CORPORATION
Crystal River Unit 3
Docket No. 50-302

December 5, 1995
3F1295-03

Subject: Technical Specification Change Request No. 203, Revision 0
Small Volume Eddy Current Indication Disposition

**TECHNICAL SPECIFICATION CHANGE REQUEST NUMBER 203
SMALL VOLUME EDDY CURRENT INDICATION DISPOSITION**

Figure 1

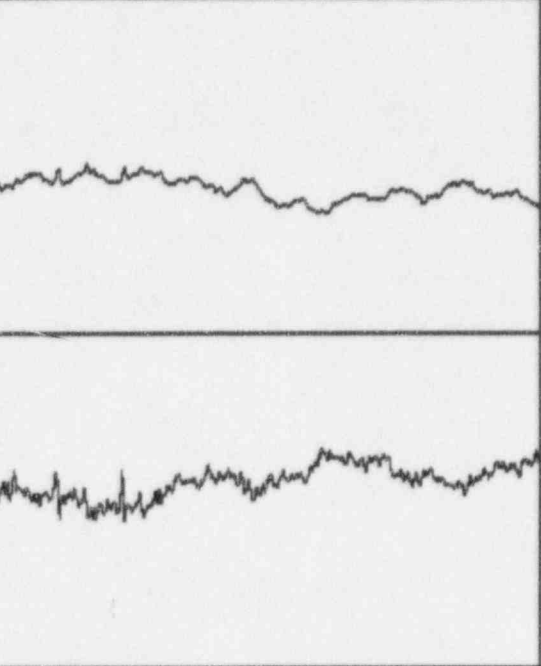
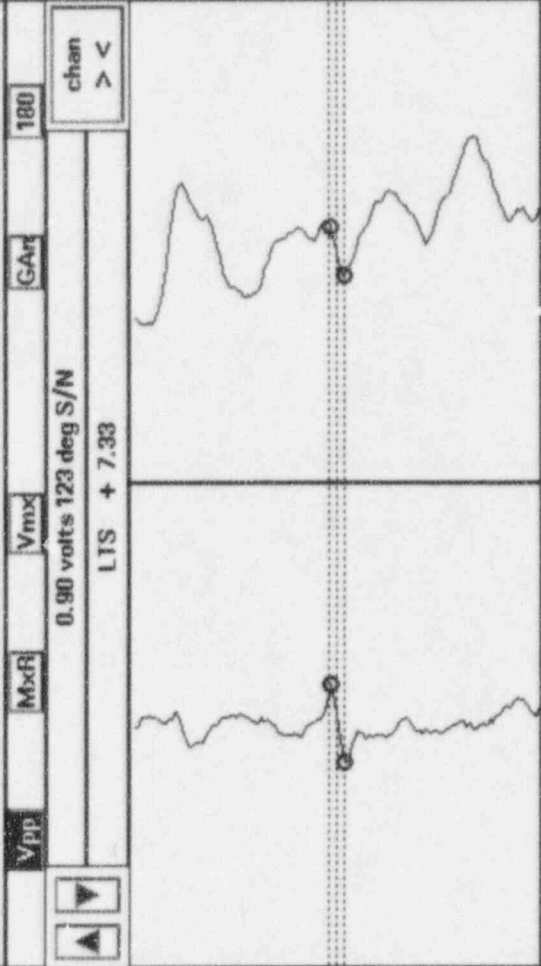
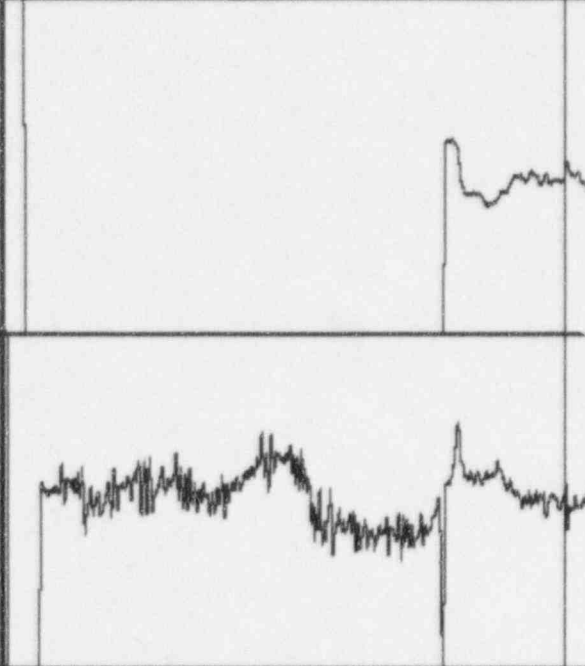
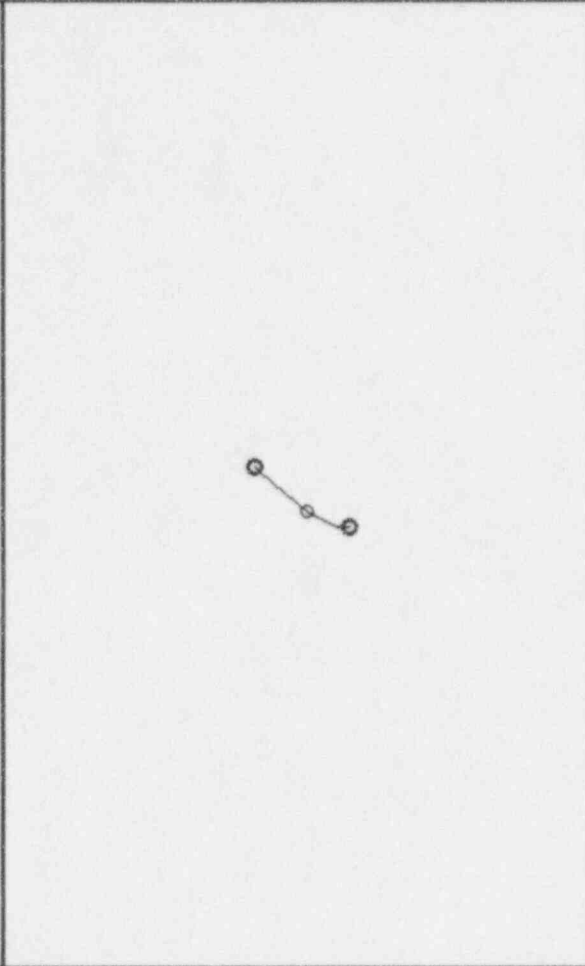
5. What actions have been taken to decrease the noise or increase the defect response signal during eddy-current inspections at CR-3? Discuss the use of alternate probes (size and type), inspection frequencies, assessments of noise origin, and other potential signal improvement measures. What alternative inspection techniques have been used in the past or been considered for the next inspection of S/N indications?

Figures 1 and 2 provide a pictorial illustration of how the S/N ratio is determined. The two Figures are bobbin coil graphics of an indication located in 1992 CR-3 pulled tube 41-44, section 2. This tube section corresponded to the first span of the 'B' OTSG and the indication illustrated was confirmed to be pit-like IGA by destructive examination. From Figure 1, the indication exhibited a bobbin coil signal amplitude of 0.90 volts. Figure 2 illustrates Steps 3 and 4 above, determining a peak-to-peak voltage value of 0.31 volts attributable to noise. Using Figures 1 and 2 in conjunction with one another, a S/N ratio of 3:1 is calculated ($0.90V/0.31V$) for this indication.

Figure 3. Voltage scatter plot from two consecutive outages for freespan indications attributed to pit-like IGA; CR-3 Steam Generator B.

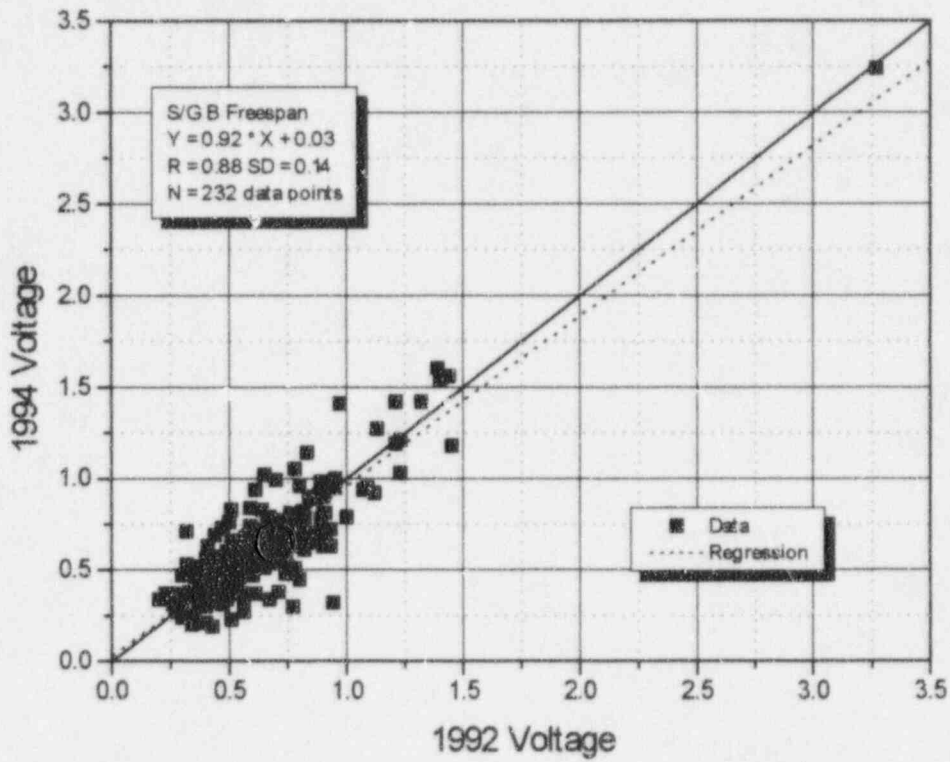
15. An S/N indication is considered to have grown if it exhibits a 0.5 volt increase from the previous inspection and has a measured voltage in excess of 0.9 volts. The basis for the 0.5 volt increase resides in the fact that this criterion was used in the previous inspections of S/N indications. Provide technical justification for not performing a subsequent RPC examination of indications previously RPC examined unless the bobbin voltage increases by 0.5 volts. If an indication was identified as having an eddy current response of 0.4 volts and was later reexamined and found to exhibit a 0.8 volt response, discuss why this indication is not considered to have grown. The staff notes that since the degradation mechanism is considered dormant and no allowance for flaw growth was used in the development of the tube repair criteria, there should be essentially no change in voltage with the exception of variations arising from nondestructive examination uncertainty. Since the probe wear model and analyst variability model being proposed have a total uncertainty of approximately 24% at an upper 95% confidence level, it seems like a much lower threshold than 0.5 volts should be used. Please discuss. Is the 0.5 volt increase determined from the most recent inspection of the indication or from the original inspection in which the indication was identified?

Figure 3 shows a scatter plot of measured voltages for freespan indications from two consecutive outages attributed to pit-like IGA from CR-3 steam generator B. The measured voltages are essentially uniformly distributed about the zero growth line at 45 degrees indicative of no overall change. This observation is also supported by data presented in Figure 4 and Figure 5 which show amplitude change in volts and percentage respectively. Scatter plot and histogram formats are used in both figures to show changes. Voltage change was determined by taking the difference between the 1994 and 1992 data; percentage change was determined by dividing the voltage change by the average of the 1992 and 1994 measured voltages.

The 0.5 volt threshold originally proposed for establishing change essentially bounds all of the data for pit-like IGA (Figure 4(a)), and most of the data for wear at tube support plates (Figure 7(a)). However, with a two-sigma NDE system repeatability error of 0.21 volts for free-span IGA, a more-conservative threshold of 0.25 volts for growth could be utilized. This increase would be applied using the most recent inspection data.

Figure 9. Depth-volume correlation using Crystal River 3 pulled tube metallographic data.

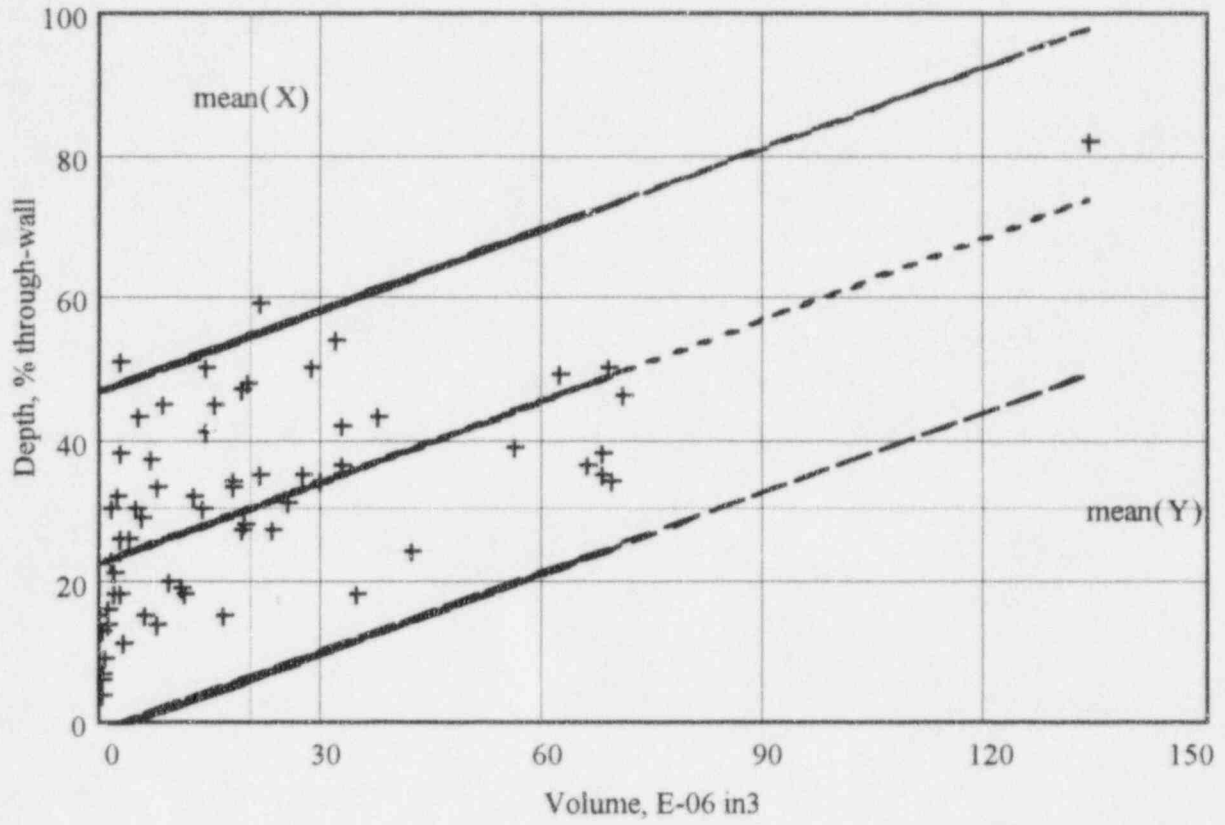
17. Independent staff calculations determined that leakage integrity is not assured at a 95% confidence level for indications with a bobbin coil signal of 0.9 volts. Discuss the 0.9 volt lower limit in light of this staff finding. Consider the response to Question 18 below.

FPC calculational results do not agree with the NRC Staff's. For a bobbin coil signal of 0.9 volts, the volume and depth are estimated using Figures 9 and Figure 12. From Figure 12, the volume is estimated at 90×10^{-6} in³ at the upper 95% prediction interval. Using Figure 9, this volume corresponds to a depth of 80% through-wall at the upper 95% prediction interval. Since this depth is less than 87% through-wall, leakage integrity is maintained.

95% prediction intervals for data presented as Figure 5-1 through 5-5 in (Reference 1) are shown as Figures 9 through 13 herein. Linear scaling of the prediction interval plots as opposed to log-log plots of the original data is used because of software limitations. In addition, for Figure 11, volume has been correlated with the circumferential extent *in mils* rather than *inches* as originally presented in order to be consistent with the axial length correlation.

Figure 14. Number of S/N Indications in Active Tubes of CR-3 RCSG-1A Following Refuel 9 as a Function of Bobbin Coil Voltage

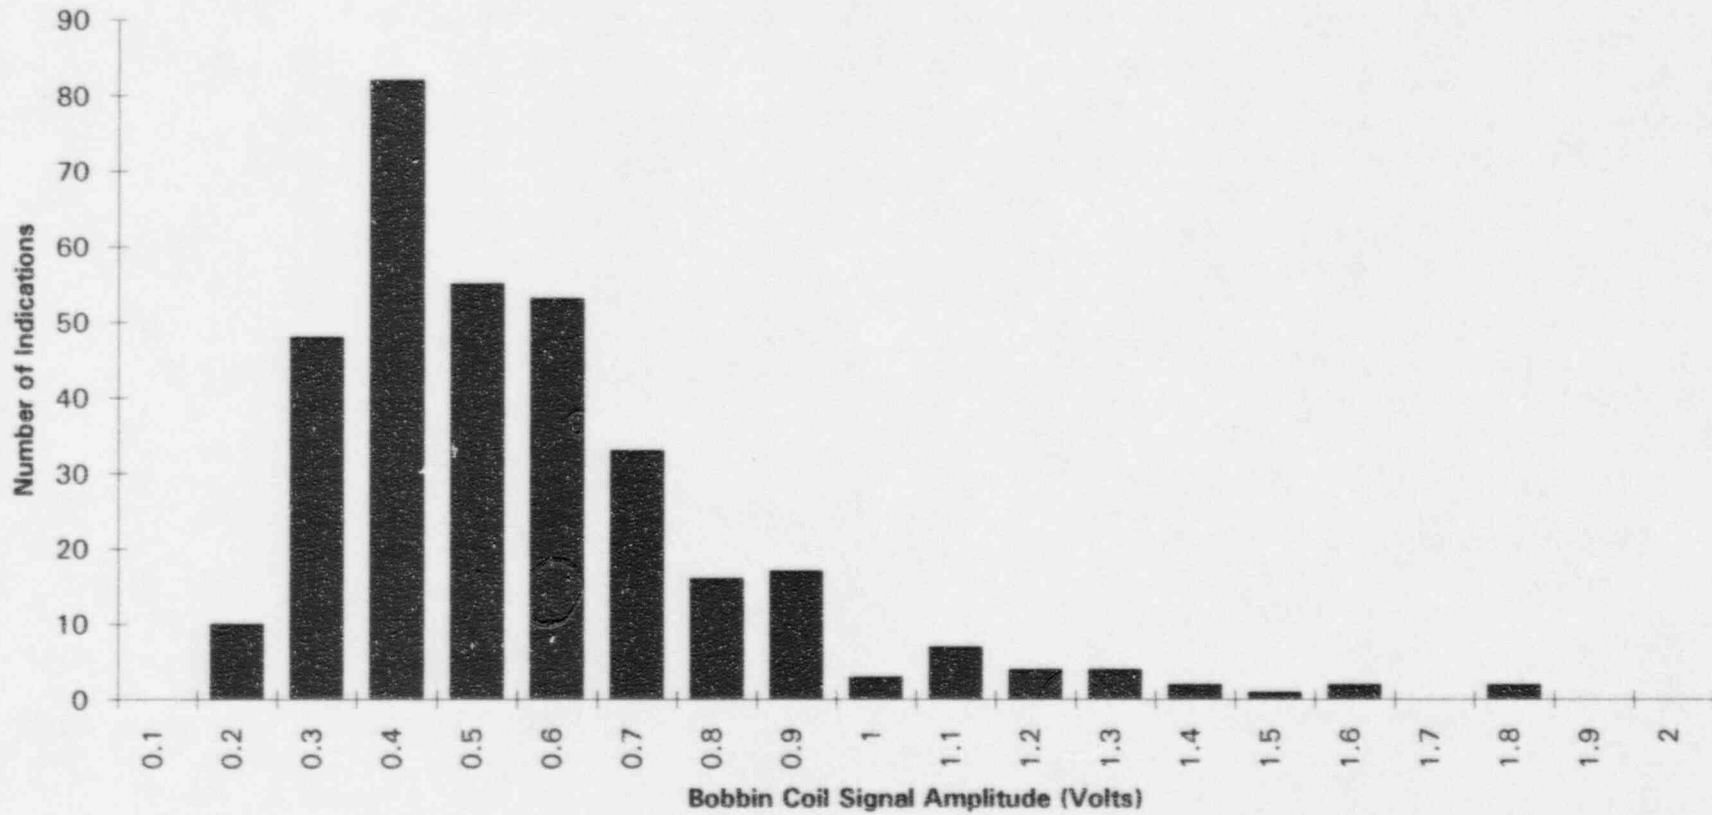
40. The labeling of the vertical axis of Figure 1-4 in Reference 3 states that the data is given "per 100 tubes inspected." Provide graphs showing the voltage distribution of all S/Ns currently in service in steam generator "A" and steam generator "B" (i.e., exclude the tubes repaired in 1994). How many active tubes in each steam generator have S/N indications?

The graphs requested are presented as Figures 14 and 15. Based upon Refuel 9 inspection results, there were 290 active tubes in 'A' and 817 tubes in the 'B' OTSG which contained S/N indications. A review of the CR-3 historical eddy current database indicates 351 active tubes in 'A' and 892 active tubes in 'B' have been assigned an S/N code in at least one outage since 1983. The difference in the two numbers is believed to be principally attributable to certain small amplitude signals "fading" in and out from one outage to another (discussed in the response to RAI #9), as well as a number of S/N indications which have changed designation for one reason or another over the years.

Figure of Volume-Axial length correlation using additional 8 data points.

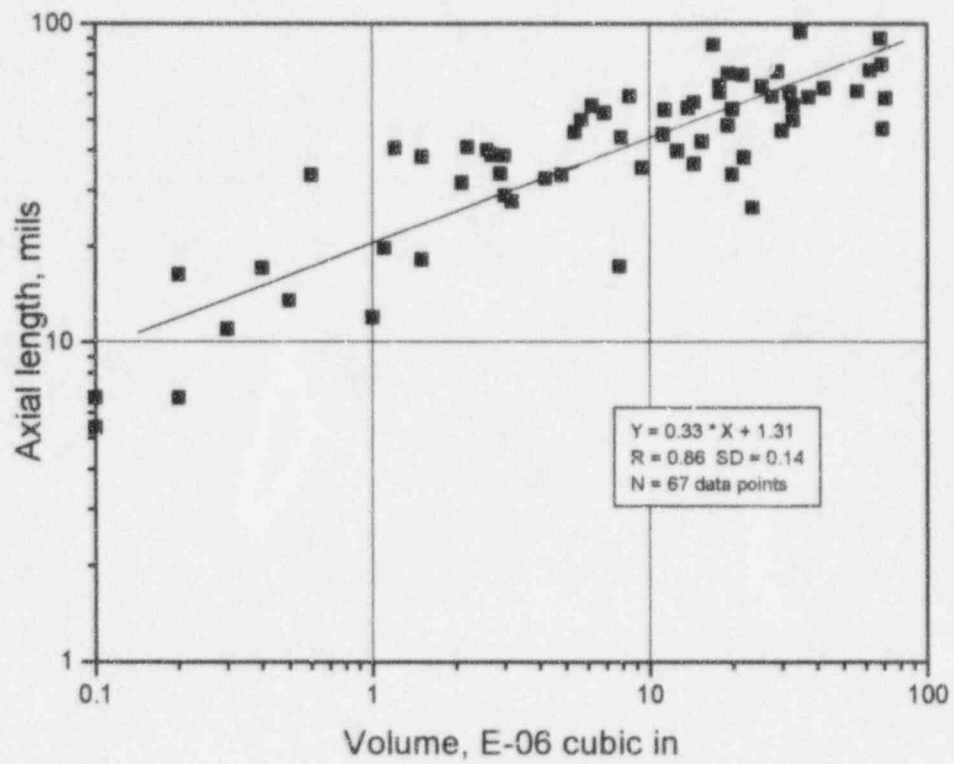
- b. Identify which specimens were included in each correlation. For specimens with multiple discontinuities that were too close to be distinguished in the field non-destructive examination (i.e., within the proposed 0.2" band), provide details on what dimensions were used in the various correlations and/or analyses, annotate specimens that were combined, provide the data used for the combined data point, and indicate in which correlation this combined data point was used (e.g., the depth used in the probability of detection study). For example, if an "indication" was missed, was the largest, smallest, or a combination of the defect dimensions used in the POD curve, voltage versus volume correlation, etc. For specimens excluded from any correlation, discuss the reason for excluding them. Discuss if any significant indications were not included in a correlation since they were not destructively examined. For example, in the POD correlation, were any large laboratory detected indications which were not detected in the field not included in the analysis since they were not destructively examined.

Axial and circumferential extents for the additional eight data points were not originally included in the correlations because the dimensional information was not available. This explains why Figures 3-5 and 3-6 from (1) have 8 fewer data points than Figure 3-4 of (1). The dimensional information has since become available. When the additional data is appended to the original volume-axial length, volume-circumferential length data sets the correlation plots shown in the Figures attached. These new plots with the extended data sets compare very well with the original plots.
